DATE: March 5, 2026

ADDENDUM NO. 3

PROJECT NO. DGS C-0576-0012 PHASE 001
PROJECT TITLE - SCI Chester - Electrical Upgrades

H.F. Lenz Co.
1407 Scalp Avenue
Johnstown, Pennsylvania, 15904

SCALE: 1/8" = 1'-0"

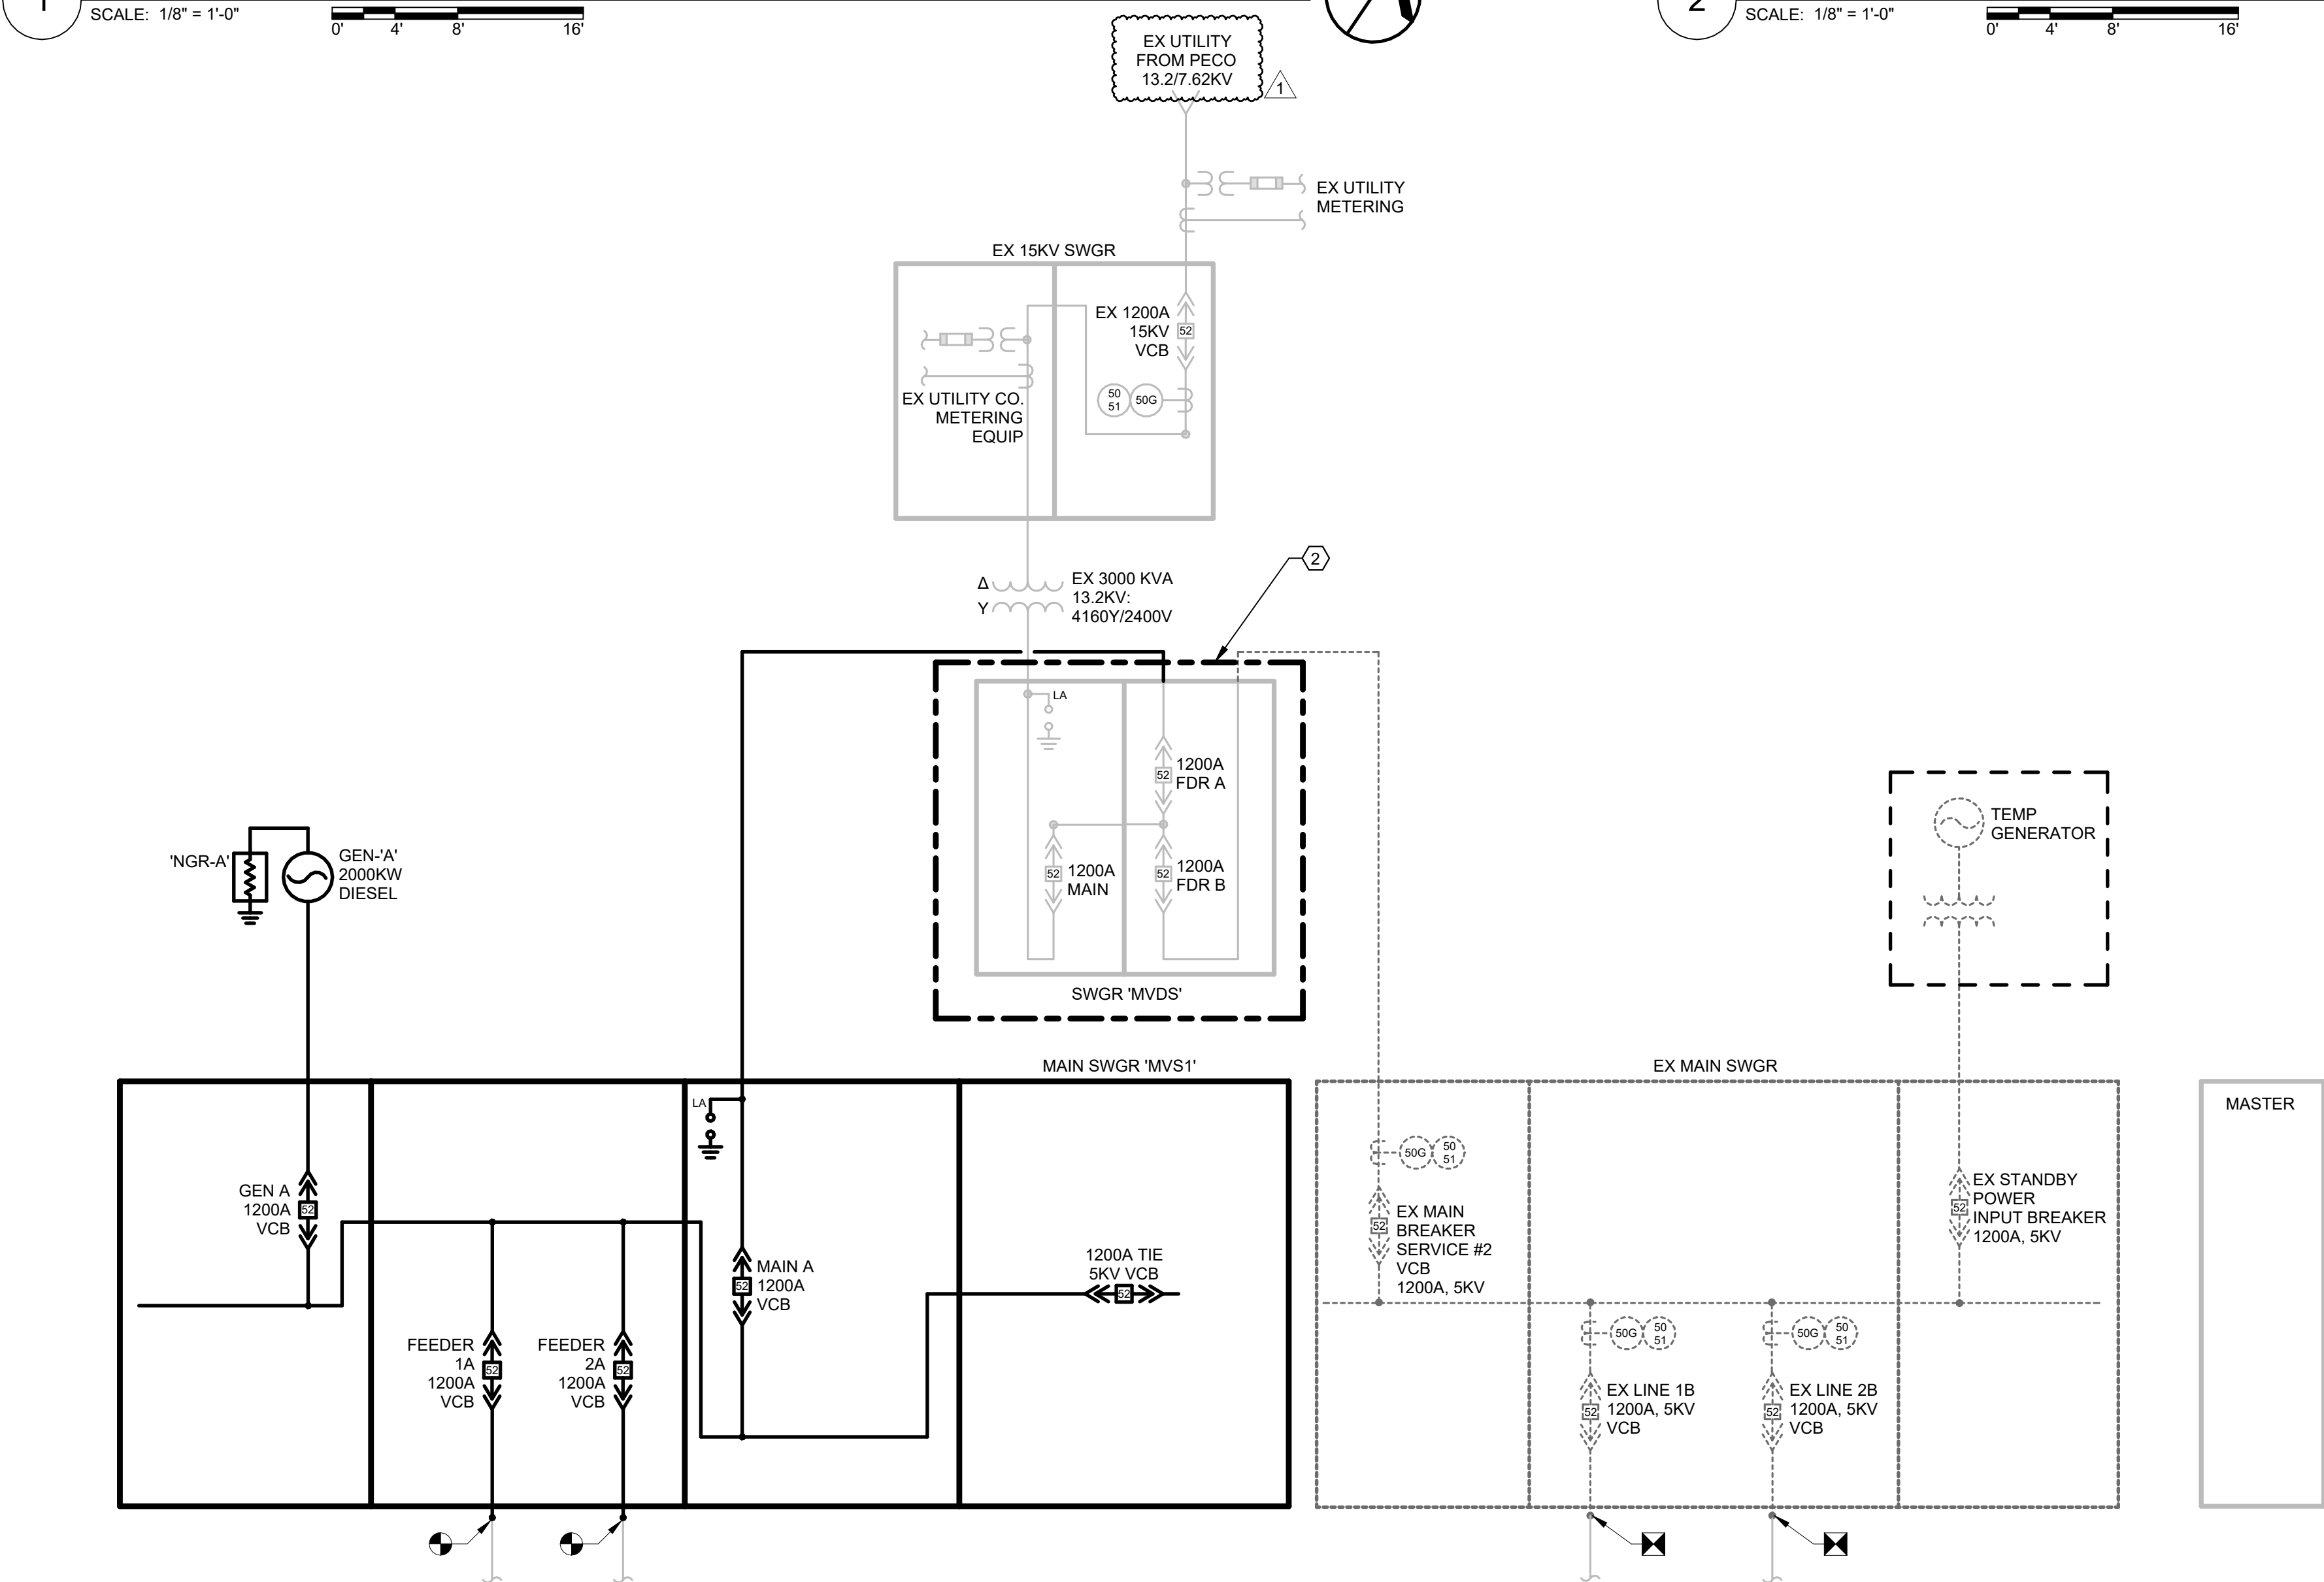
1. Drawings E-101, E-102, E-103, E-104, E-105, E-501, E-502, E-503: Voltage feeding 'EX 15KV SWGR' revised to read: "EX UTILITY FROM PECO 13.2/7.62KV"
2. Drawing E-102: Reference markers on 1/E-102 revised to reference drawing E-102.
3. Drawing E-301:

13. Question: Single line shows 480/277 volts feeding the ex 15KV SWGR main service feed is this a typo?

Response: Drawings revised to indicate service voltage of 13.2/7.62kV.

1 ROOF PLAN - DEMOLITION - ELECTRICAL
SCALE: 1/8" = 1'-0"

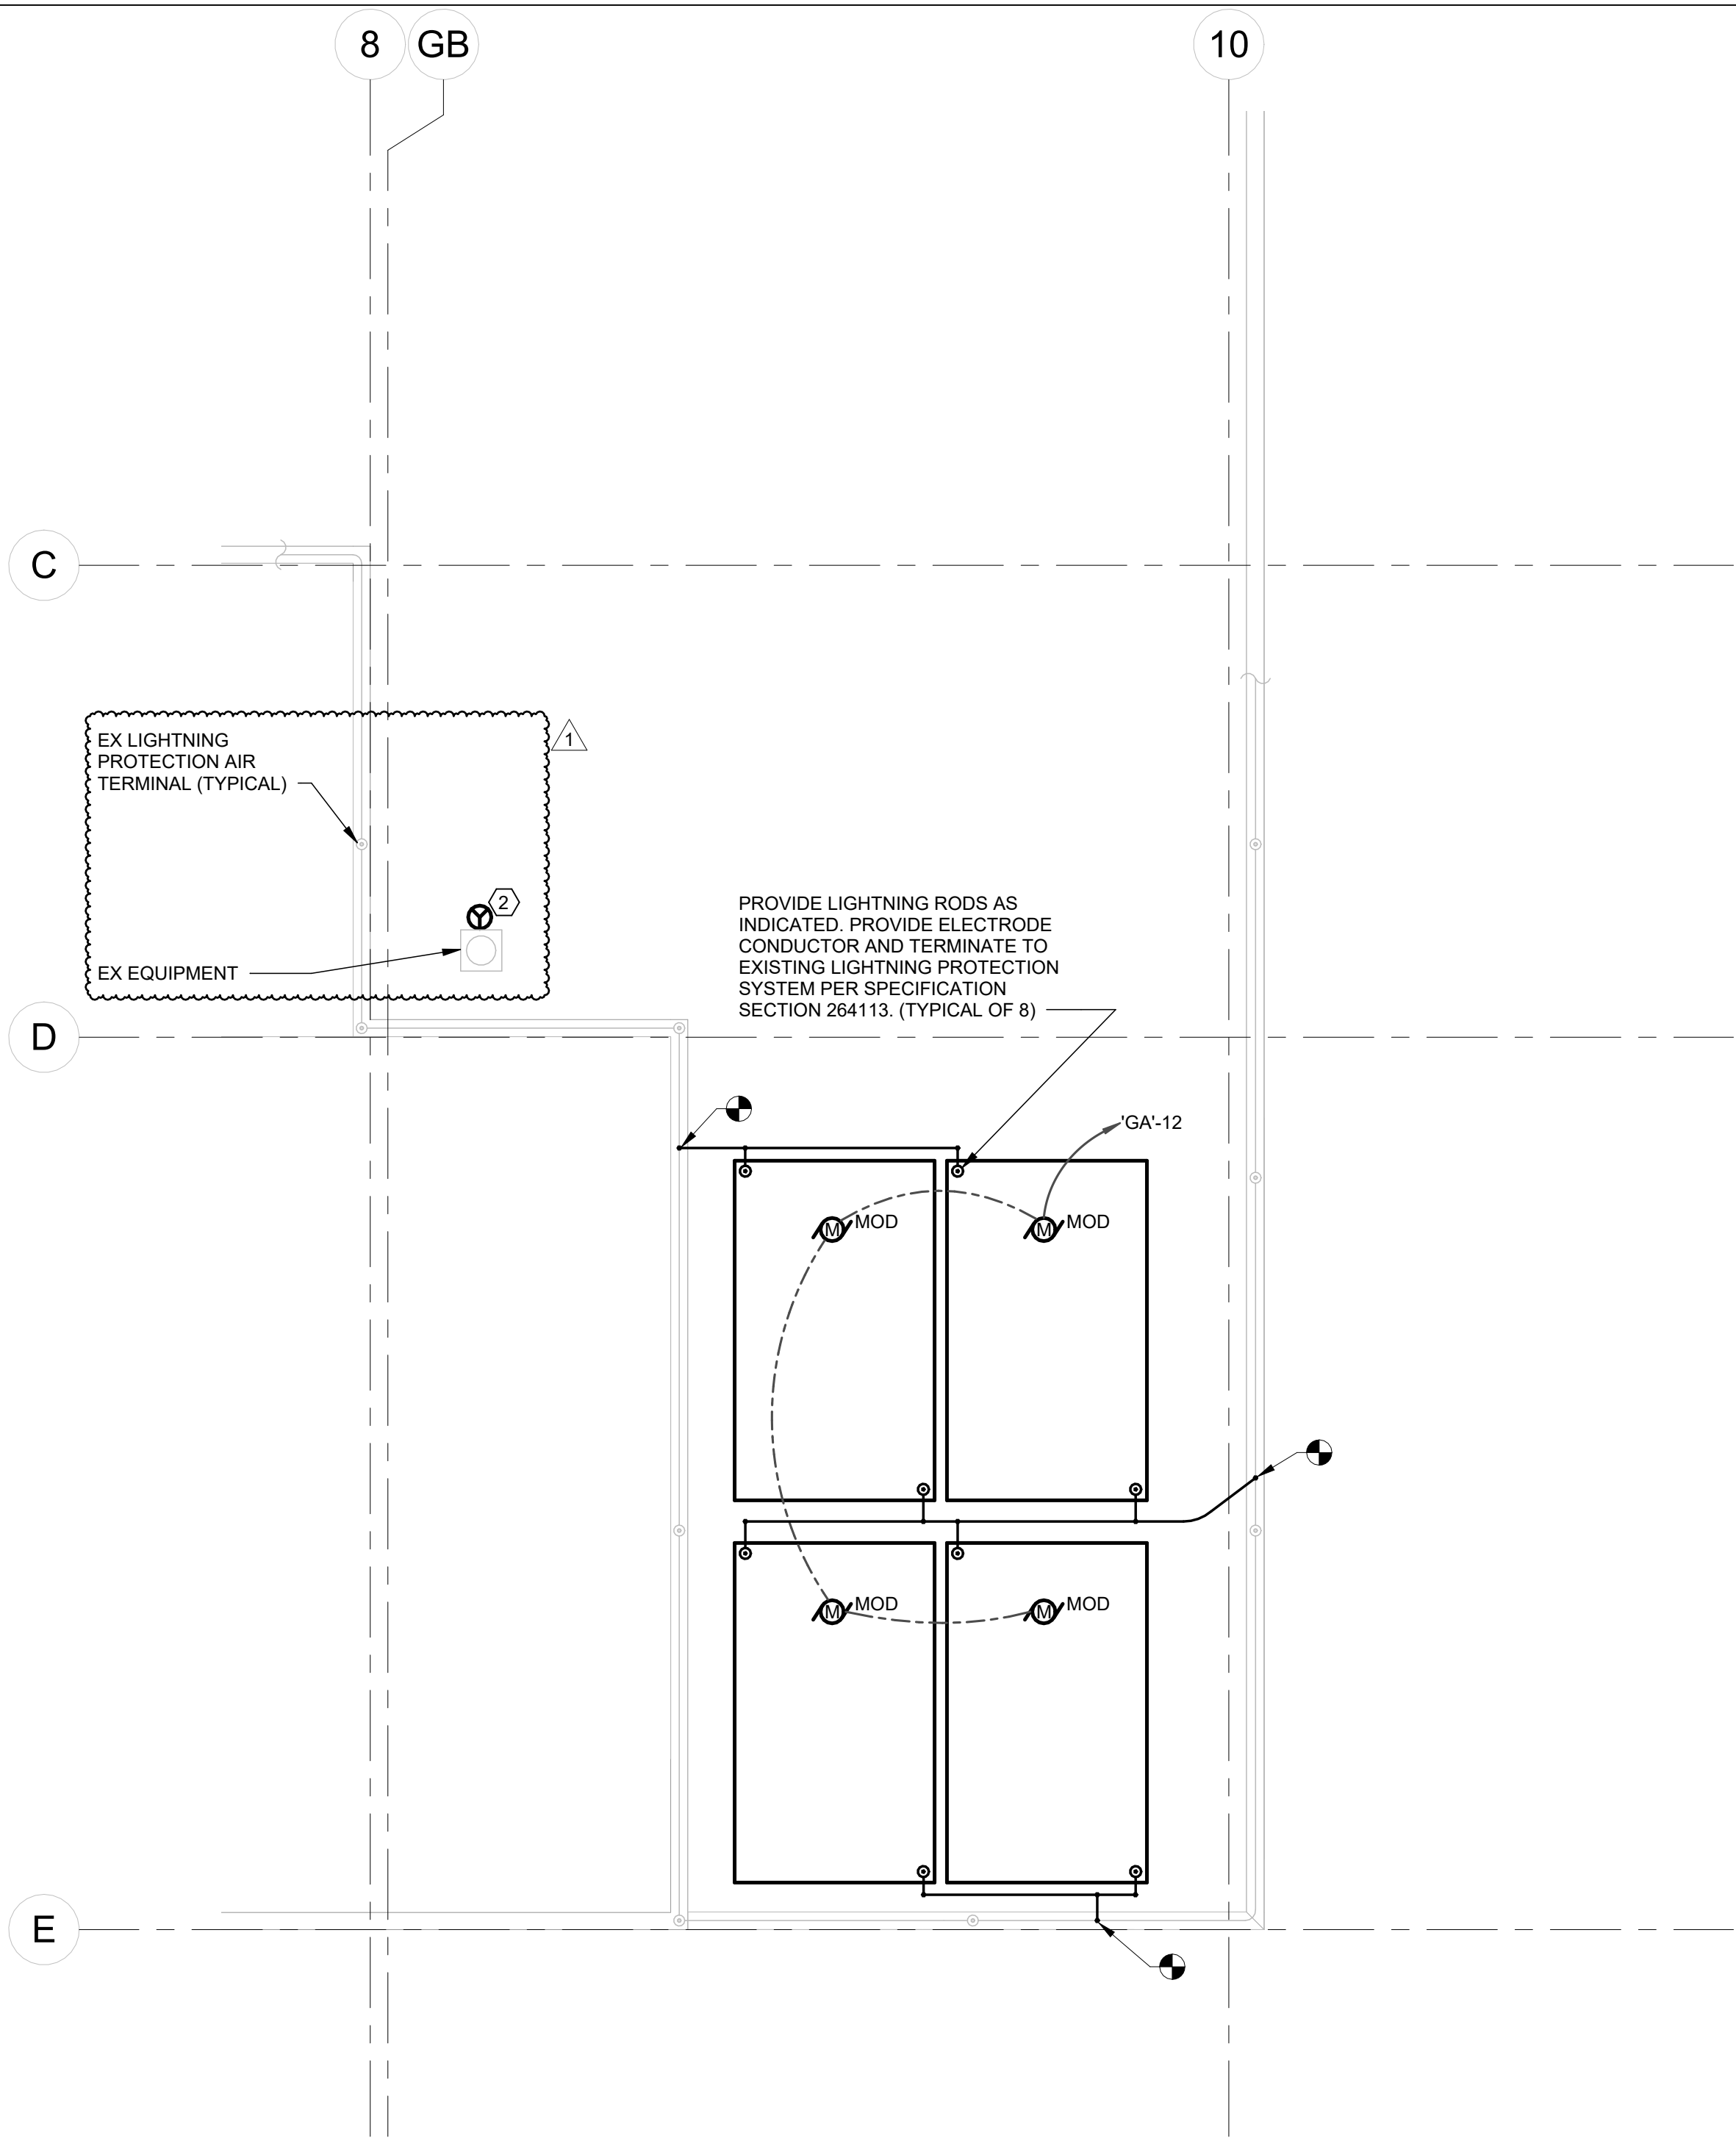
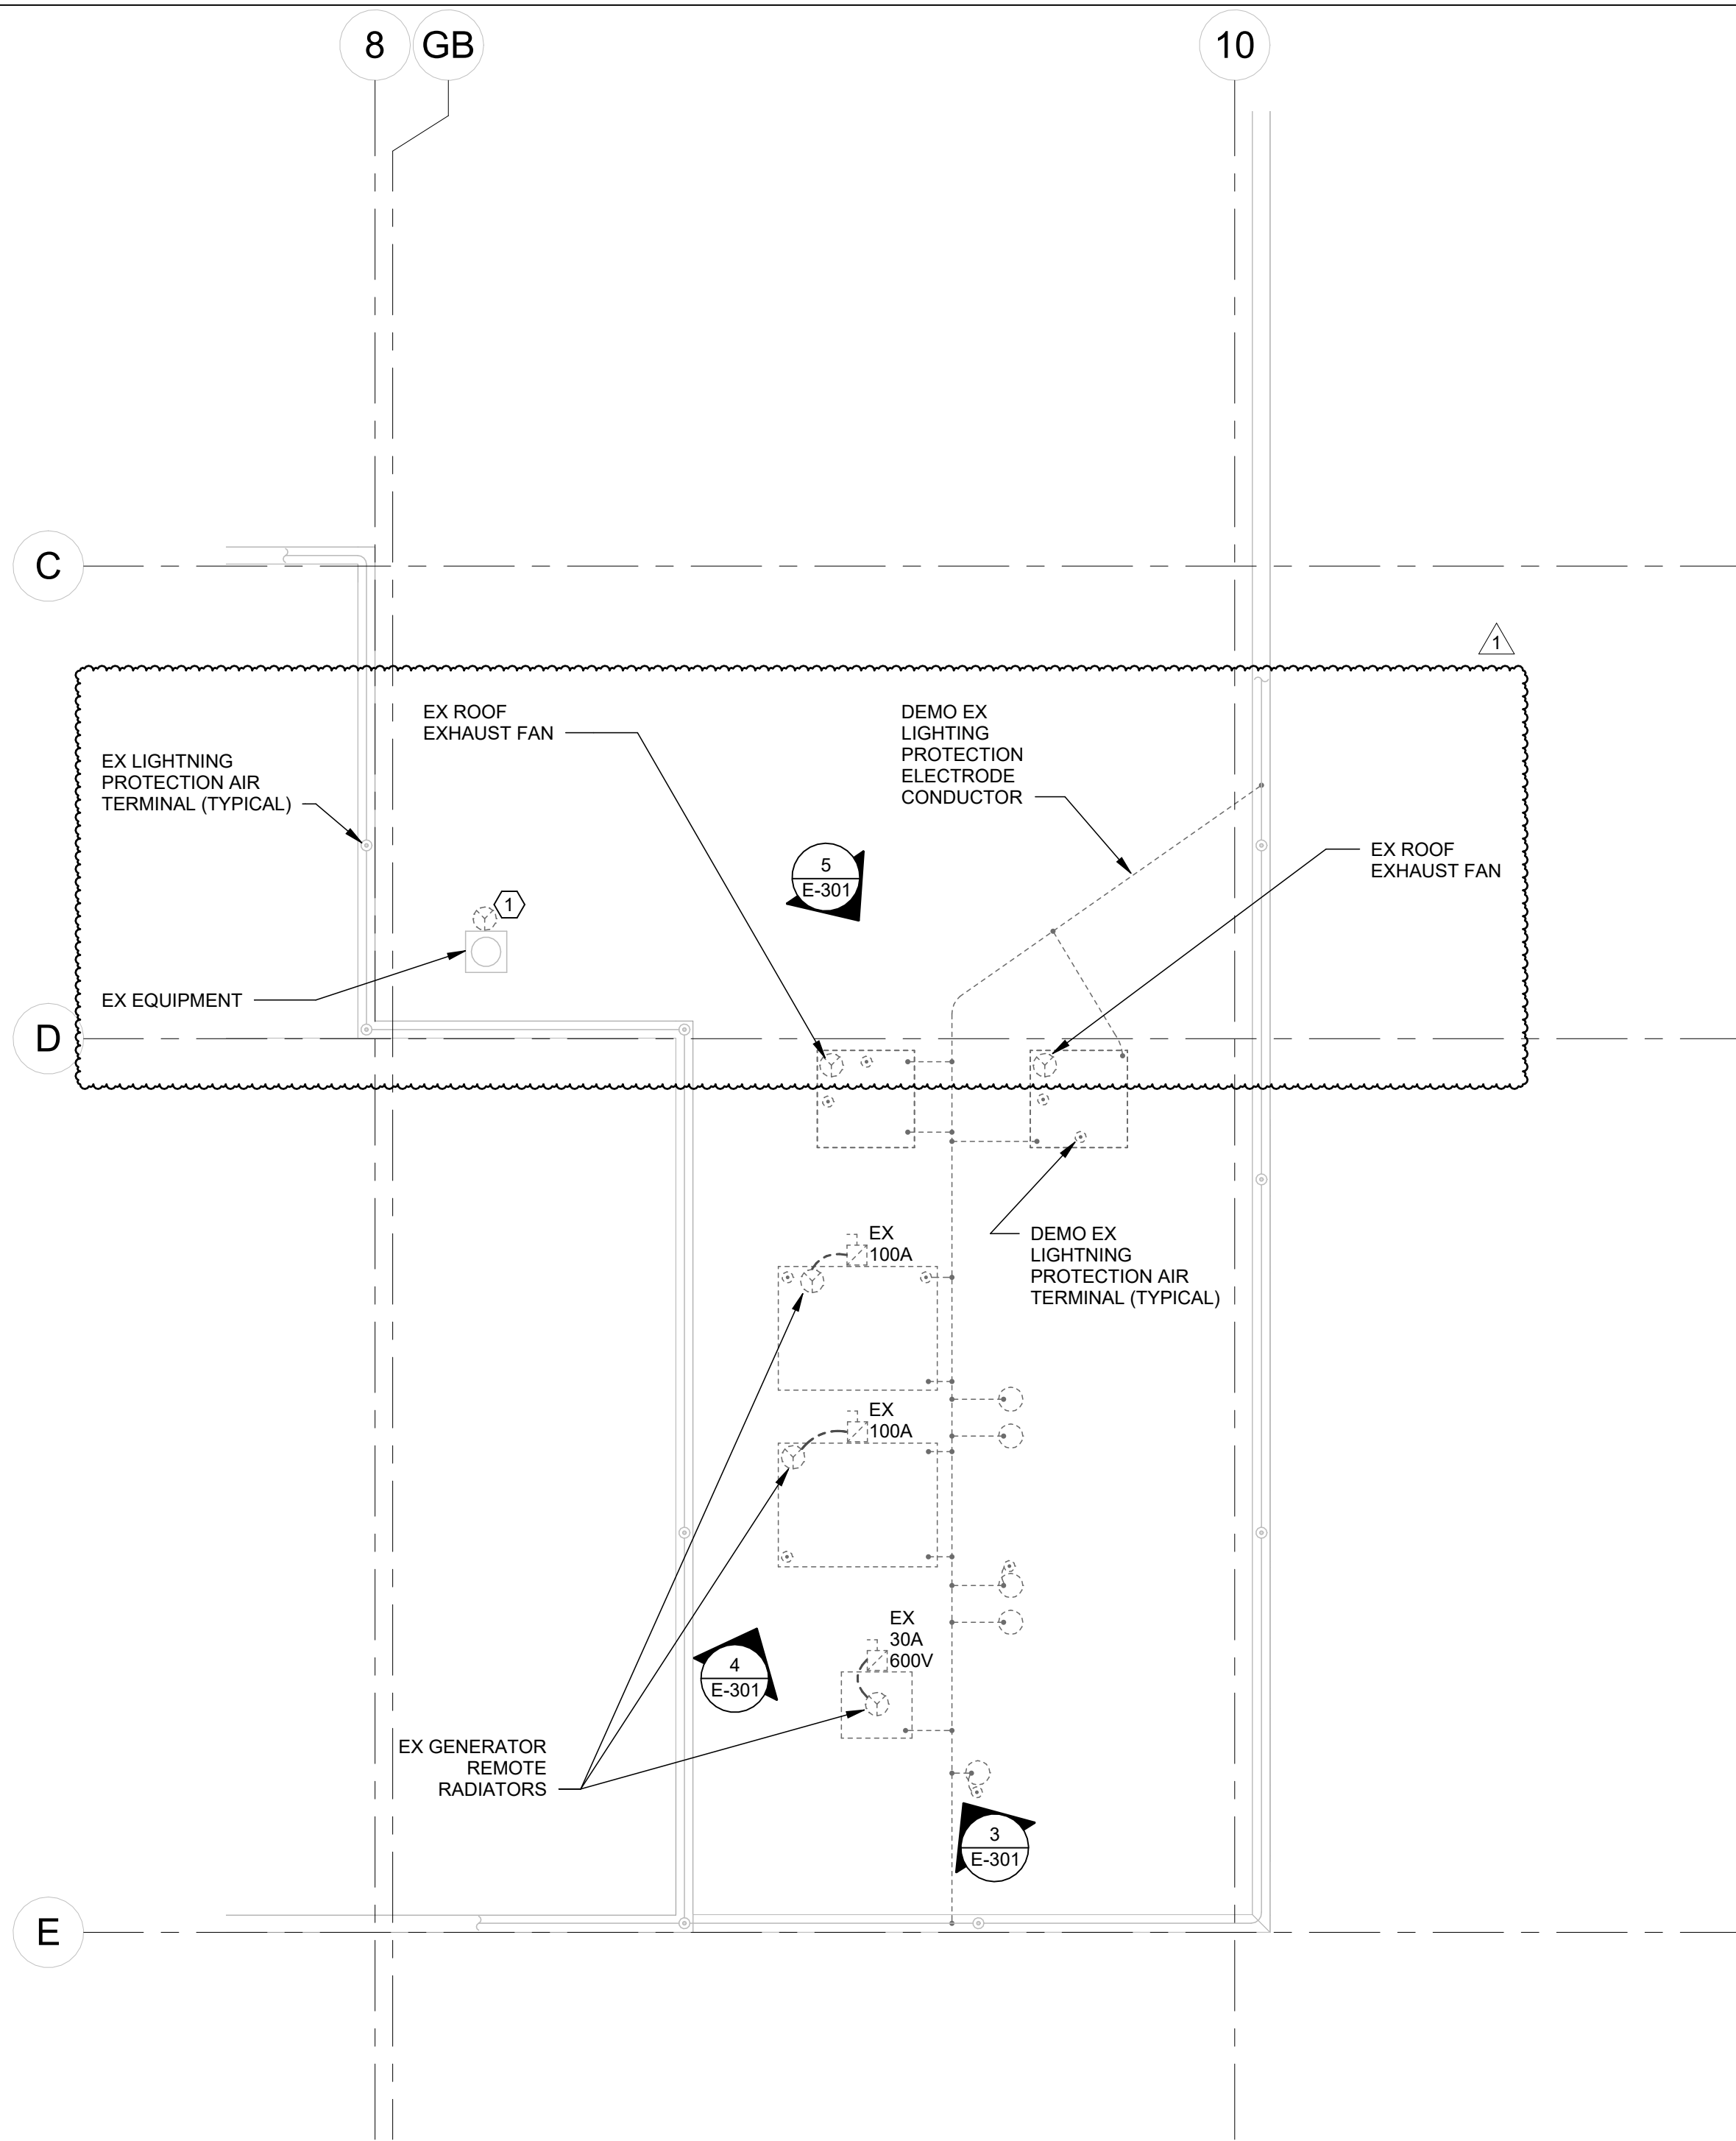
Added Keynote 1 to 1/E-301:

"DISCONNECT EXISTING EQUIPMENT. MAINTAIN EXISTING BRANCH CIRCUIT SERVING EQUIPMENT FOR REINSTALLATION. EXISTING BRANCH CIRCUIT MAY BE REMOVED BACK TO A CONVENIENT LOCATION FOR INTERCEPT AND EXTENSION."

Added Keynote 2 to 2/E-301:

"INTERCEPT, EXTEND, AND RECONNECT EXISTING BRANCH CIRCUIT MAINTAINED FROM DEMOLITION WORK FOR EXISTING EQUIPMENT. SIZES AND QUANTITIES OF CONDUIT AND CONDUCTOR SHALL MATCH EXISTING."
